Docket Number:	06-AFC-07C
Project Title:	Humboldt Bay Generating Station - Compliance
TN #:	206000
Document Title:	Petition for Project Modification- Temporary Tent
Description:	N/A
Filer:	Jonathan Fong
Organization:	PG&E/ Humbolt Bay Generating Station PM/ Chuck Holm
Submitter Role:	Public
Submission Date:	9/3/2015 10:06:07 AM
Docketed Date:	9/3/2015

Subject: Humboldt Bay Generating Station - Petition for Project Modification (06-AFC-07C), Installation of Temporary Tent

Petition to Modify – Temporary Storage Tent Installation

PG&E
Chuck Holm
25x35x24

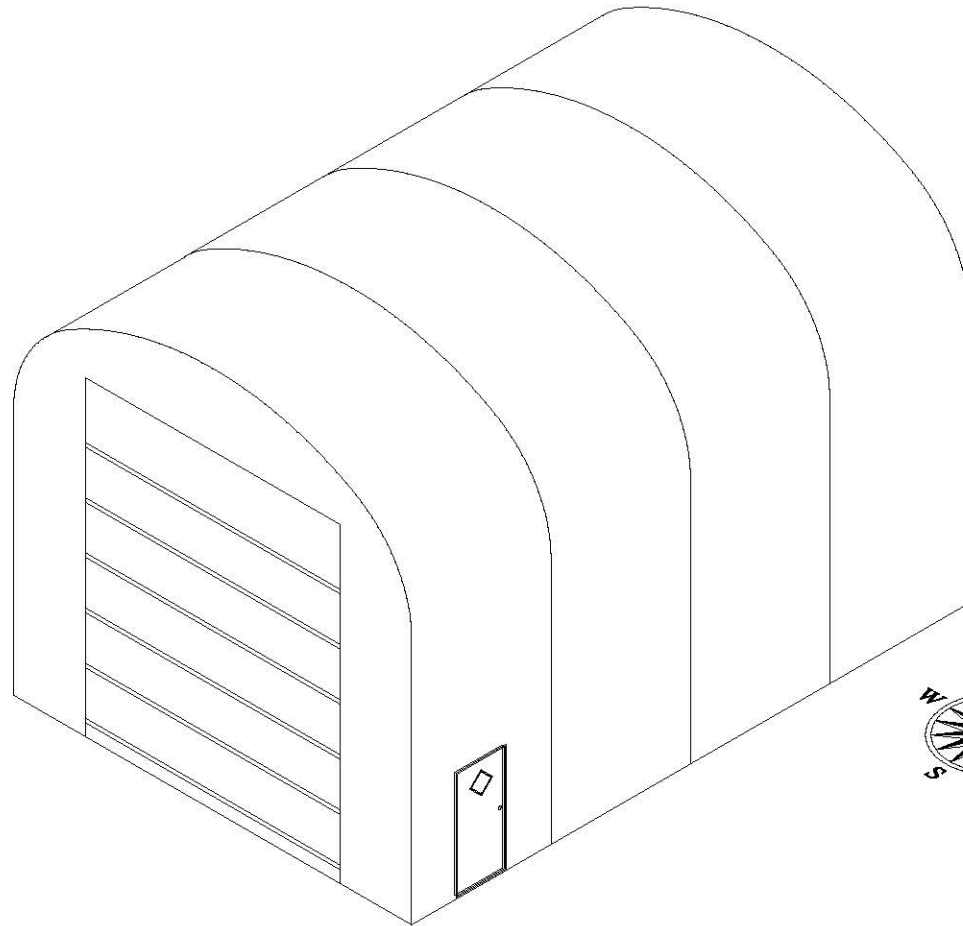
The tent dimensions will be 25' x 35' x 24'. Drawings of the tent are included in Attachment 1. The tent will be located adjacent to the Bravo Road access gate to HBGS (see Figure 1). Since HBGS does not currently use Bravo Road for access due to HBPP decommissioning activities, there is space available adjacent to the gate for the temporary tent.

Anchor Layout

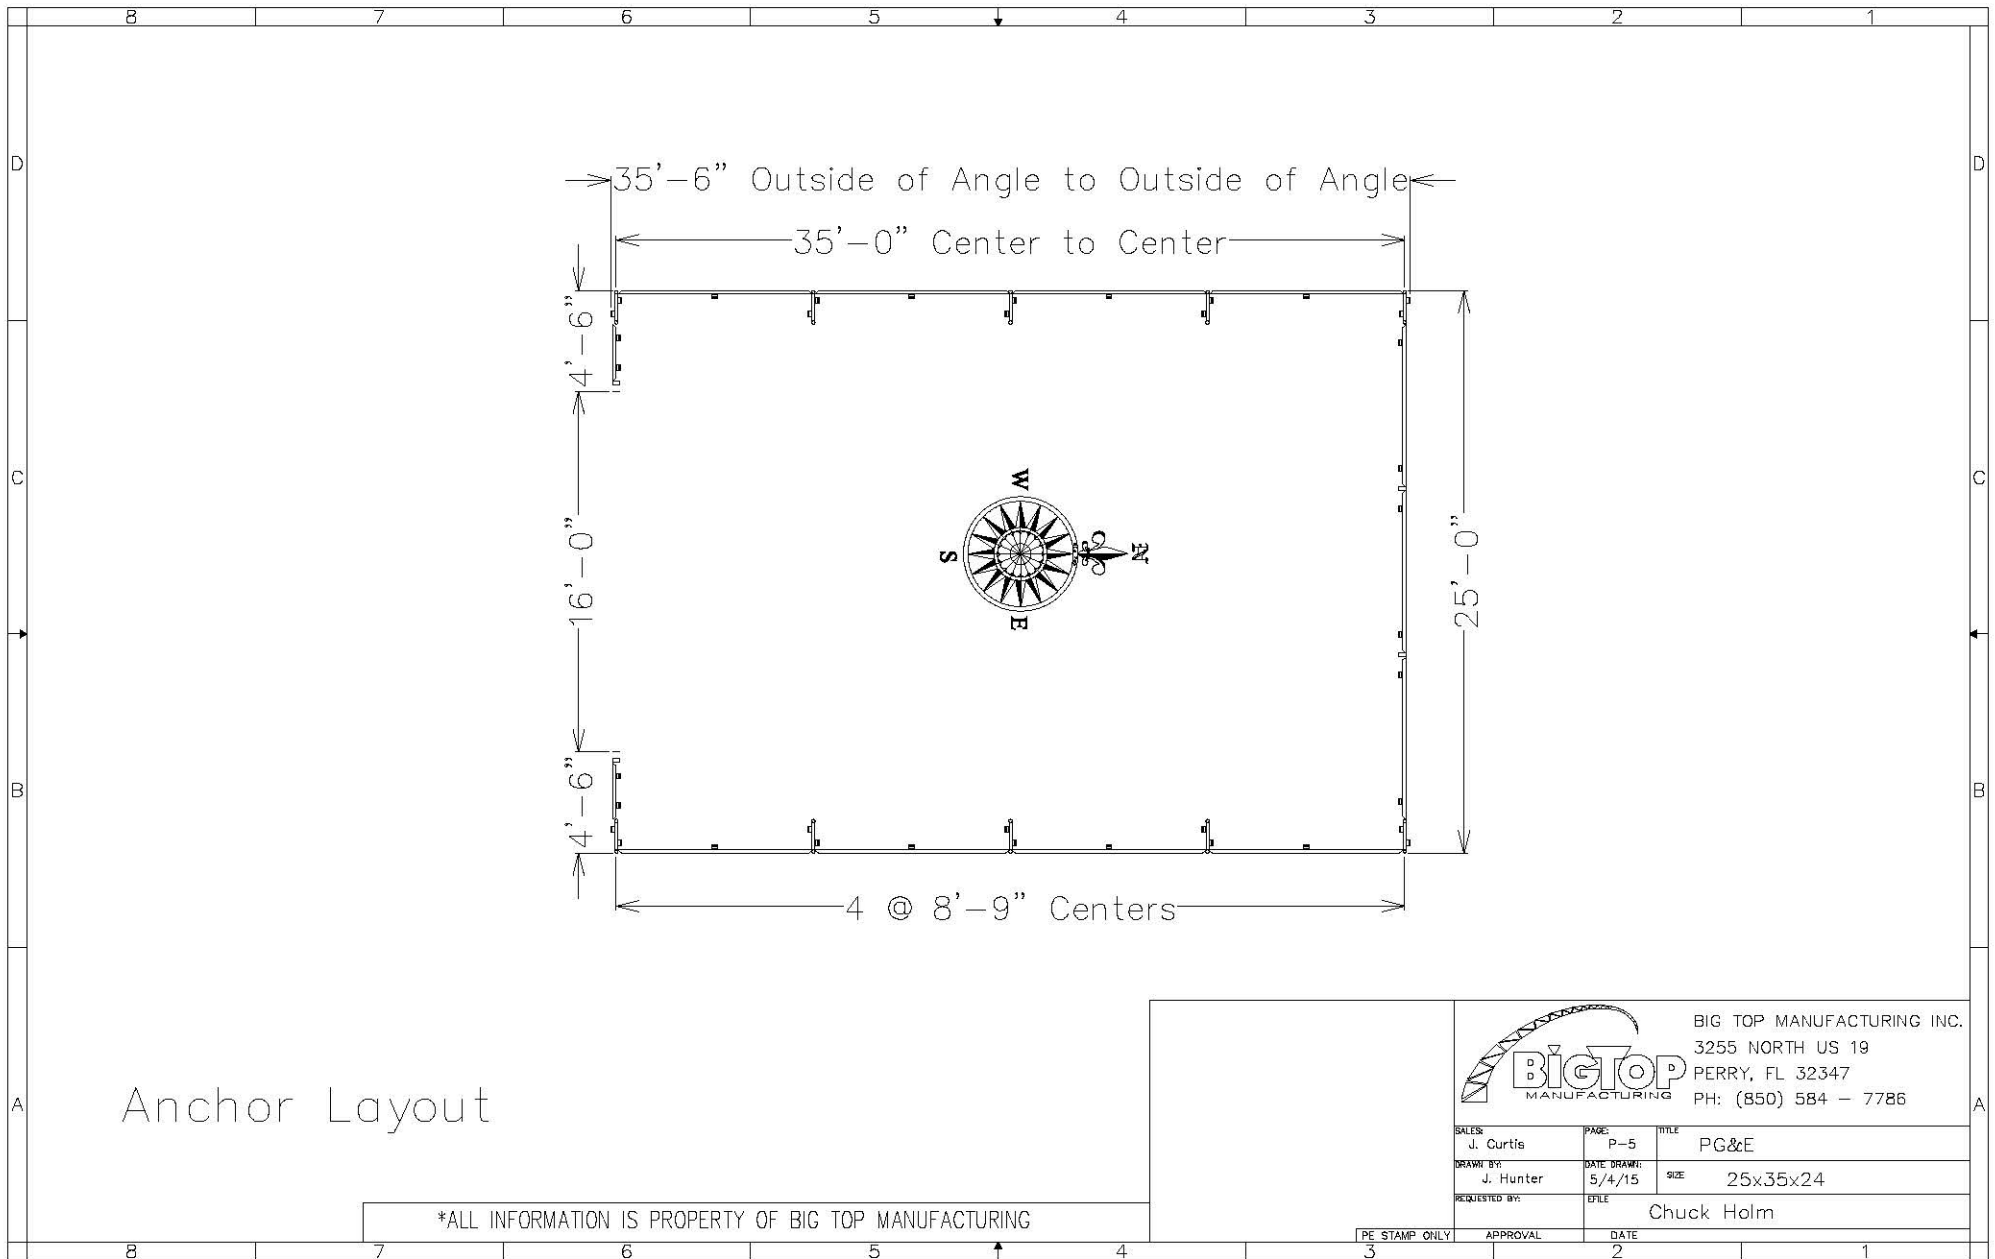
The tent will be placed on existing pavement. There will be no excavations associated with its installation. It will be held in place by 40" spiral anchor stakes, which will be installed along the perimeter of the tent (See Attachment 1, Drawings 5 and 6).
